TRANS/WP.29/GRSP/2000/2
23 February 2000

Working Party on Passive Safety (GRSP)
(Twenty-seventh session, 8-11 May, 2000,
agenda item 2.7.)

PROPOSAL FOR DRAFT AMENDMENTS TO REGULATION No. 44
(Child restraint systems)

Transmitted by the Expert from Sweden

Figure 2

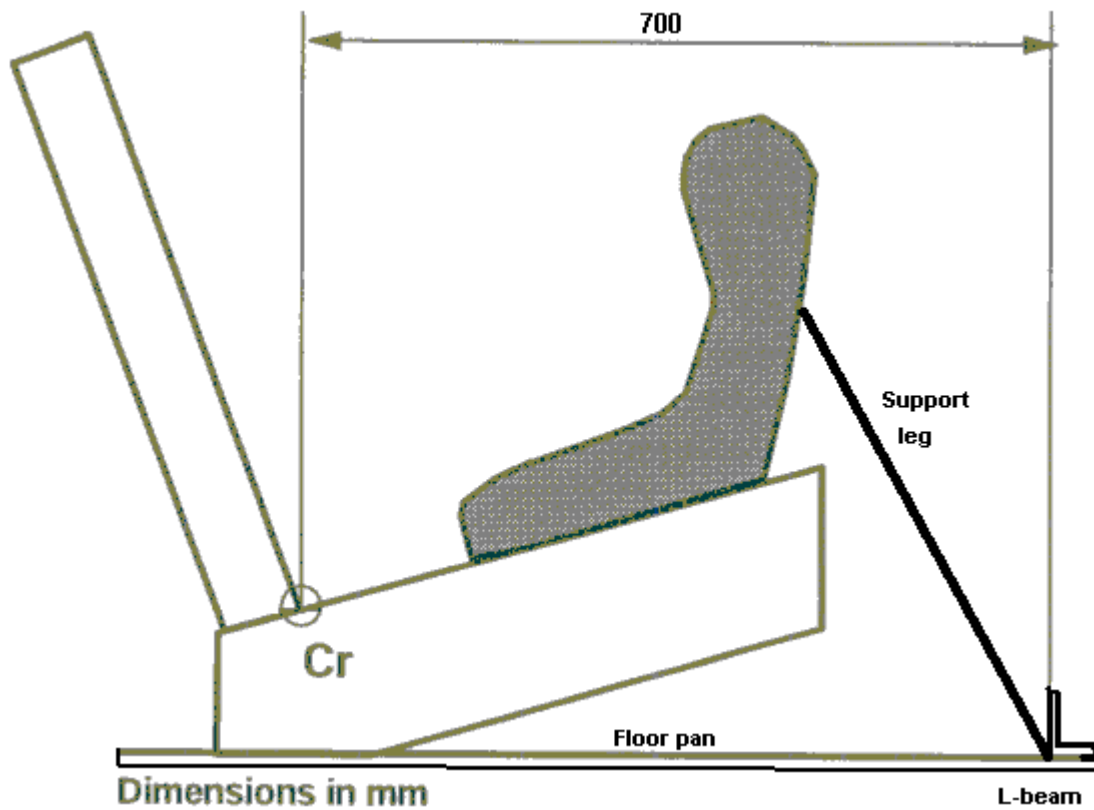
1.2.5. A beam of metal L-profile shall be fitted transversely to the trolley floor pan 700 mm ahead of line Cr in order to act as a rest for the supporting leg and simulate the front seat rear structure. The flat surface of the L-profile shall be facing the child restraint system. (See figure 2 to this annex.)

The L-profile beam shall have a length of 500 mm \pm 0.5 mm, width of 40 mm \pm 0.5 mm, height of 40 mm \pm 0.5 mm, and a minimum thickness of 5 mm.

The L-profile beam shall be rigidly welded or bolted to the trolley floor pan. If bolts are used, this shall be done with at least 3 M10 bolts.
